SERVICE BULLETIN

NO. A2866-71-1

POWER PLANT - FAN COWLING - HOLD OPEN ROD
BOND WEAR STRIP

FIGURE 1 - A2866-3 AND -4 STRUT ASSEMBLY
EXPLODED VIEW

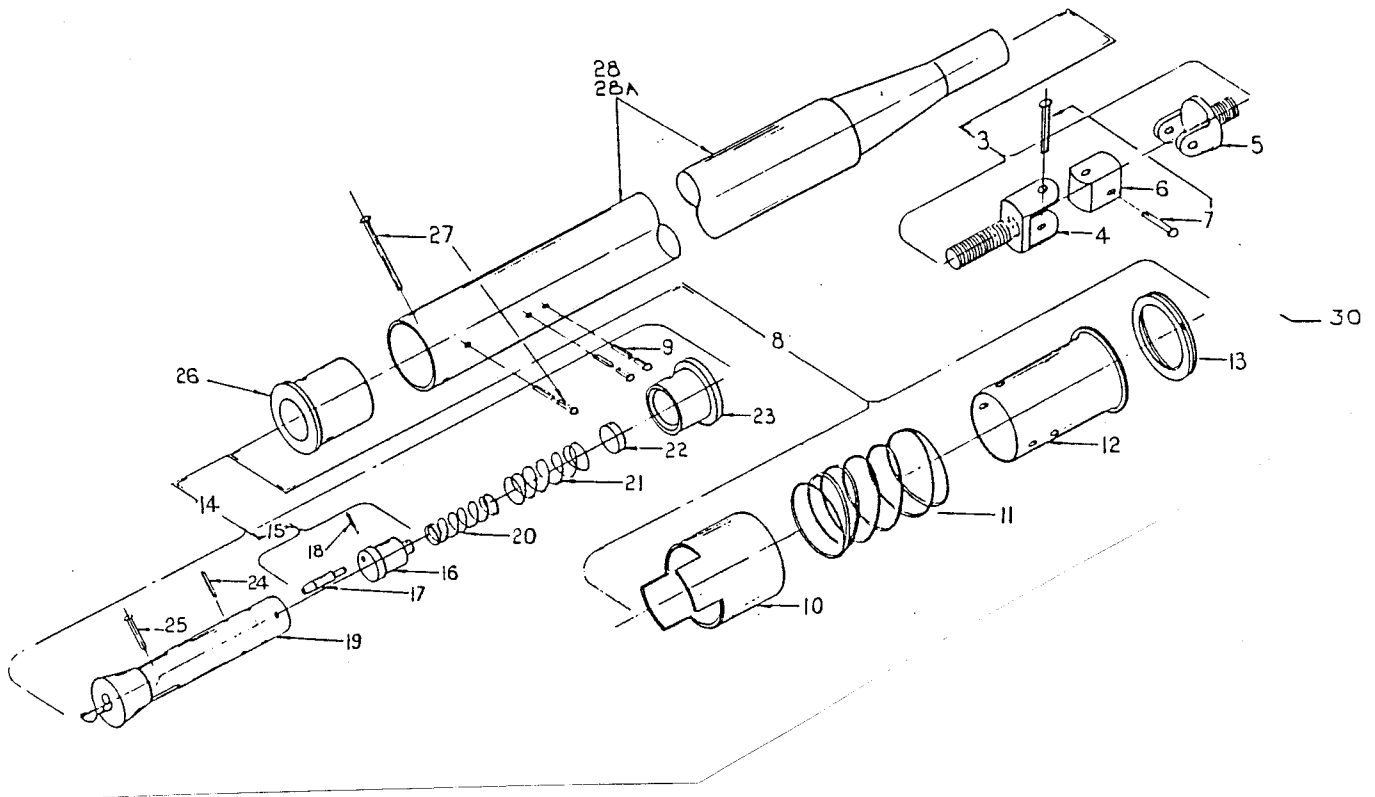
The incorporation of this Service Bulletin will replace the attachment rivets of the wear strip with a bonded joint to prevent interference with the stowage clip.

A. Disassembly (See Figure 1)

- (1) Drill out two rivets (27) using a 0.125 inch (3.175 mm) diameter drill. Remove end plug (26) and lock assembly (14).
- (2) Drill out four rivets (9) using a 0.125 inch (3.175 mm) diameter drill. Remove clamp assembly (8) from tube (28).

- (1) Remove any burrs around drilled out rivet holes.
- (2) Clean inside surface of wear sleeve (12) and outside surface of tube (28) in area to be bonded. Clean parts with lint-free cloth moist with dry cleaning solvent, 1-1-1 trichloroethane or equivalent.

- (3) Apply a thin layer of Masterbond Supreme 11 HT Epoxy Adhesive uniformly over area to be bonded. Slide clamp over end of tube (28) and position end of wear sleeve (12) 3.41 inches from the face of lock body (19) as shown in Figure 2. Rotate wear sleeve (12) so rivet holes are not aligned with holes in tube (28). Wipe off excess adhesive. Do not move for 12 hours. Allow 36 hours cure time at room temperature (70°F min.) before reinstalling in aircraft.
- (4) Insert end plug (26) and lock assembly (14) into end of tube (28) and align rivet holes. Insert two new rivets (27) and set heads by spinning.
